Re: West Mesa HS Drainage Master Plan
Engineer Stamp 1-13-09 (J10/D5)

Re: West Mesa HS Drainage Master Plan Comments Dated December 10, 2009

PROJECT NAME
ALBUQUERQUE PUBLIC SCHOOLS
WEST MESA HIGH SCHOOL
STORM DRAIN IMPROVEMENTS
6701 FORTUNA RD NW
ALBUQUERQUE, NM 87121

DRAINAGE
MASTER
PLAN

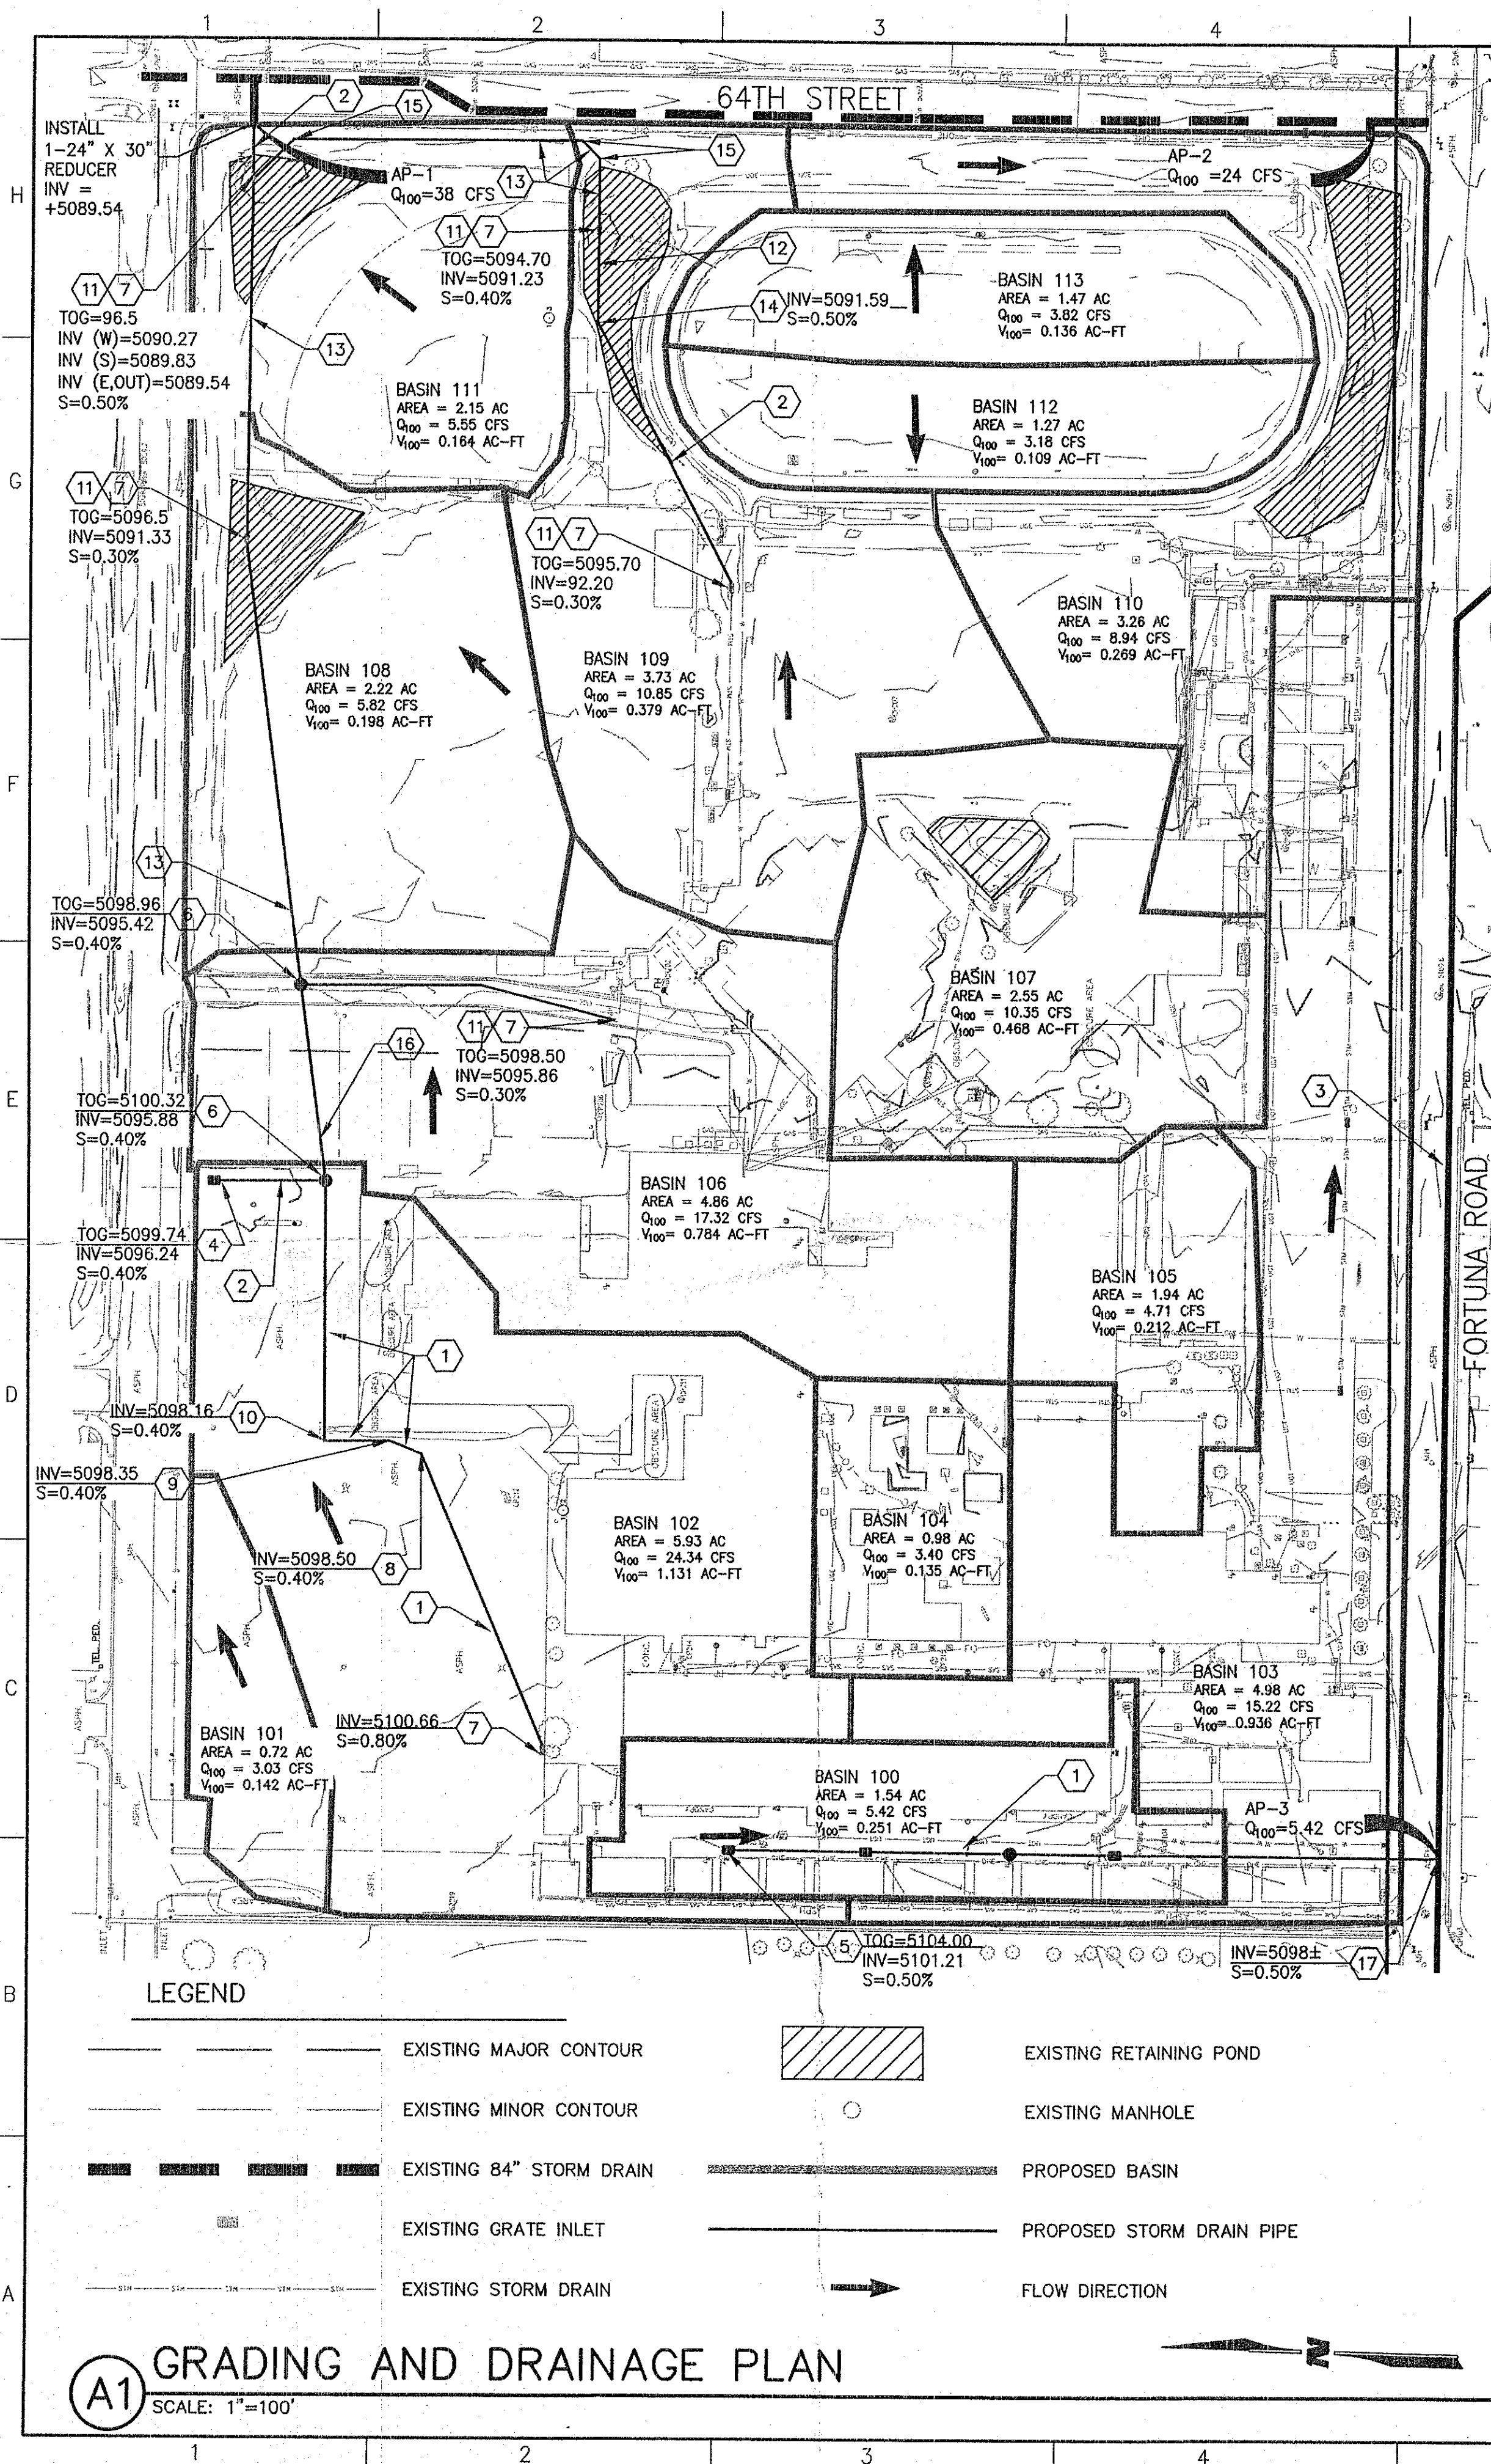
Comment 1: "Please provide calculations for all proposed 18" pipe. I cannot find the proposed 24" storm drain."

Comment 2: "There should be no Land Treatment 'A' analyzed since this site is developed. Sports areas should be a 'B' and the area with bare dirt should be a 'C' since it has probably been compacted by human use over the years."

Comment 3: "I do not find evidence of the 4 foot deep ditch routing basin 102 to the inlet in basin 108 nor the 3 foot ditch routing basin 104 thru basin 105."

Comment 4: "In the AHYMO run, you have basin 104 routed thru 105 in a 3 foot channel twice yet you propose an 18" pipe? Please explain."

Comment 5: "Does basin 106 go through basin 109 or basin 108? The AHYMO run says 109 but the basin map doesn't agree."

Comment 6: "Please label all storm drain, inlets, etc., and provide all important information regarding slope, inverts or other design or capacity factors. Are any of these items needing maintenance or upsizing?"

Response: A hydraulic model using Hydraflow Storm Sewers was developed and is submitted with this response to show that the proposed storm drain is able to convey the flows from the site. Also, 24", 30" and 36" pipe is needed and is identified on the revised Grading and Drainage Master Plan.

Response: All land treatments have been revised incorporating Comment 2. Land treatments were also updated using the latest aerial imagery which resulted in some increase in impervious area. The original and revised land treatments are shown in the following table:

Response: The ditches do not exist on the site and were removed from the model. Also, all routing of the basins was removed from the model because the small travel times did not reduce the peak flows noticeably. The flows from the AHYMO model were then input into the Hydraflow hydraulic model as described in Comment 1.

Response: The 3 foot channel was removed from the model and the flows were input into the Hydraflow hydraulic model to determine pipe size. All proposed pipe sizes are shown on the revised Grading and Drainage Master Plan.

Response: A proposed pipe was added to the master plan to capture flows in from basins 101, 102 and 106. The flows are then piped through basin 108 as shown on the revised Grading and Drainage Master Plan.

Response: The Master Plan has been updated with all requested information. The text of the report has also been updated to reflect the revised conditions and results. Since all the storm drain is proposed, no upsizing of the pipes is needed at this time.
